APPENDIX O

Email Correspondence – WCC Parks
and Recreation

From: Rowan Cordwell <Rowan.Cordwell@wcc.govt.nz>
Sent: Saturday, 25 April 2020 11:24 AM
To: Tayla Beck
Cc: Jim Warwick
Subject: RE: Karori Pool project and Ryman boundary - northeast fence

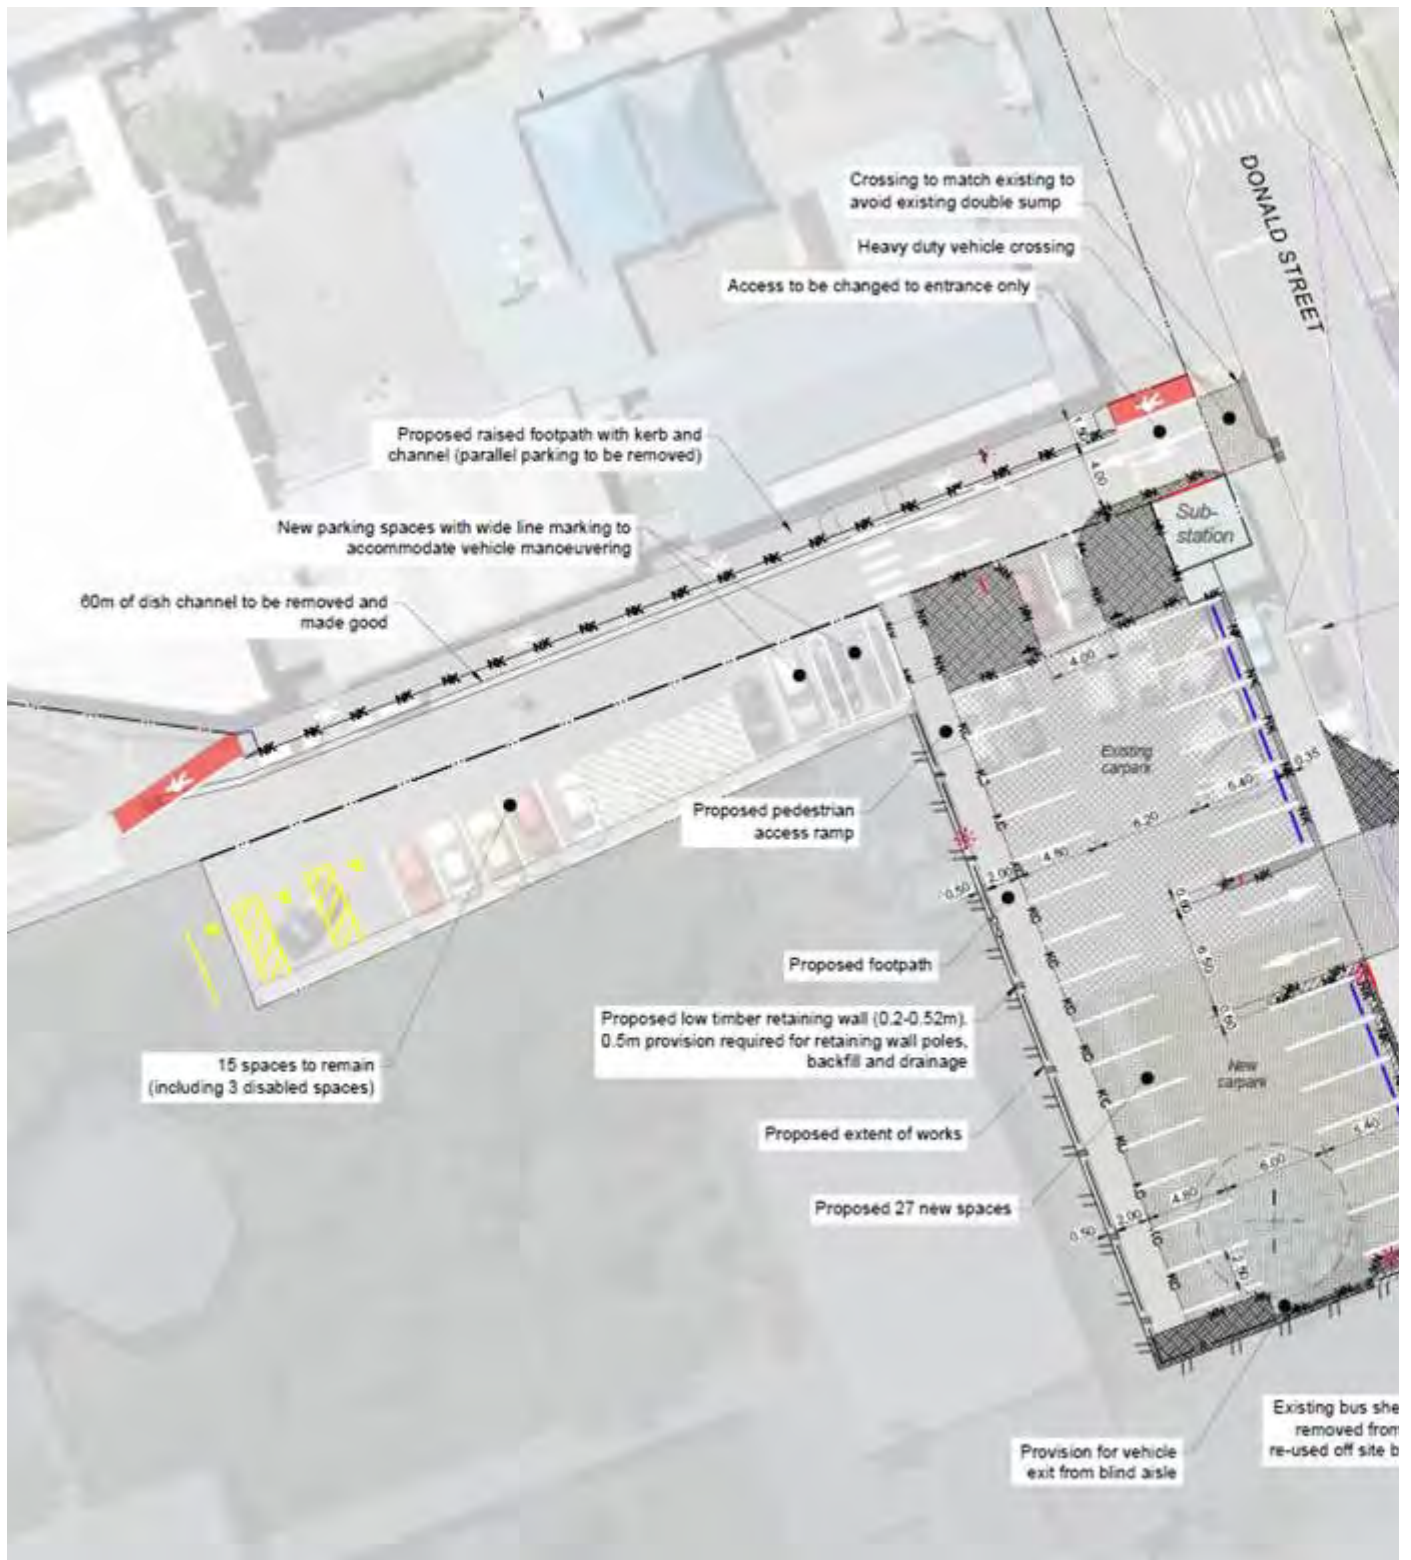
Carpark: We wouldn't be keen to lose a park, but – when you come out of the gate you don't immediately hit a carpark – there is a 2 meter wide pedestrian path between the fence and the carpark spaces. See snip below. So my assumption is this 1 meter area would be incorporated in the pedestrian walkway – are you able to confirm with the fire engineer my assumption is correct?

The fire engineer has confirmed that the pedestrian pathway is an acceptable form of egress from the gate and meets the clearance regulations as long as we have approval from Council to egress on this titled land. Our evacuation meeting point would still be on the footpath along Donald Street.

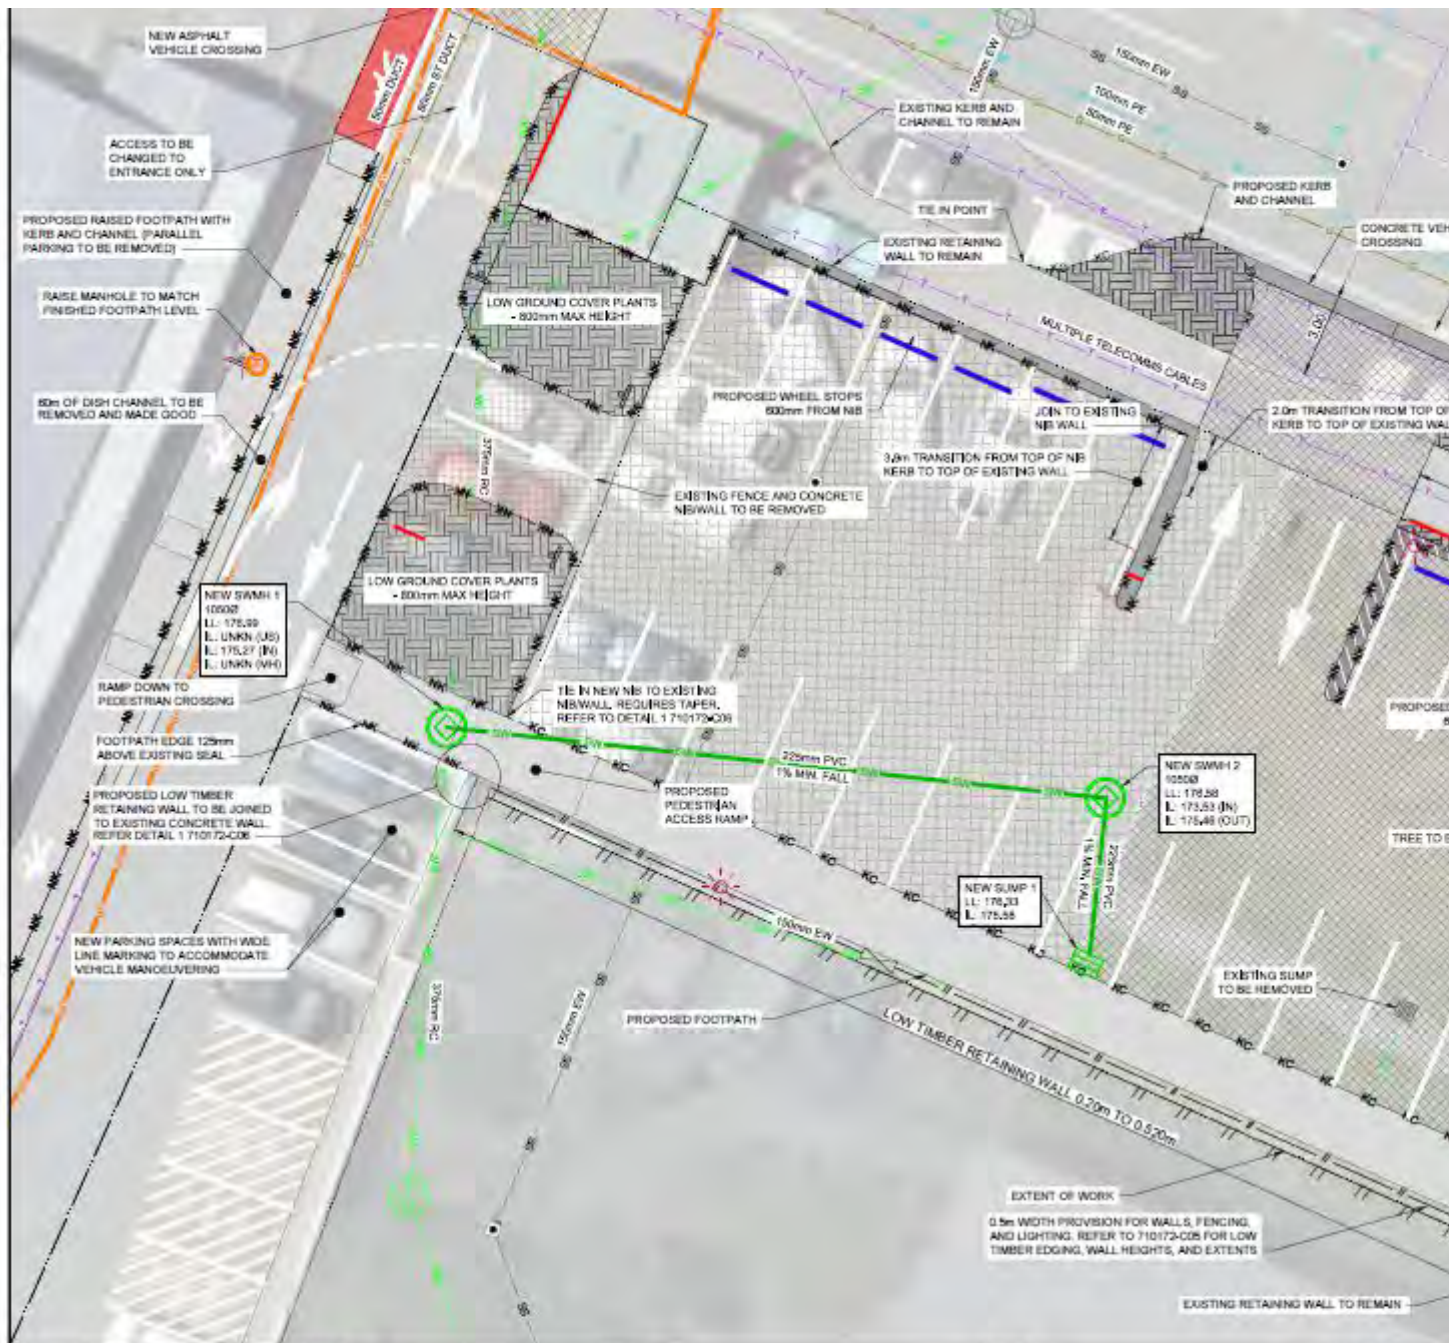
Stormwater: Our engineers have a done their plan – snip 2 below. Was there an issue around the stormwater?

Good news re the fire escape. Looks like there are no issues here.
Re the stormwater – I've checked with our engineers and we don't have a plan for a retention tank. They have confirmed they have sized the new pipe(s) for the increase in runoff from the old + new impervious area. This has been submitted to WCC under a BC and our engineers have also been in consultation with a Wellington Water drainage engineer who is reviewing the stormwater side of the BC.

No issue around the stormwater. We are continuing to progress our stormwater solution for our site and I was curious to see if we could incorporate some of our flows into the carpark solution e.g. if you were going to be installing a retention tank then we could potentially make this tank bigger to allow for some retention from our site also.
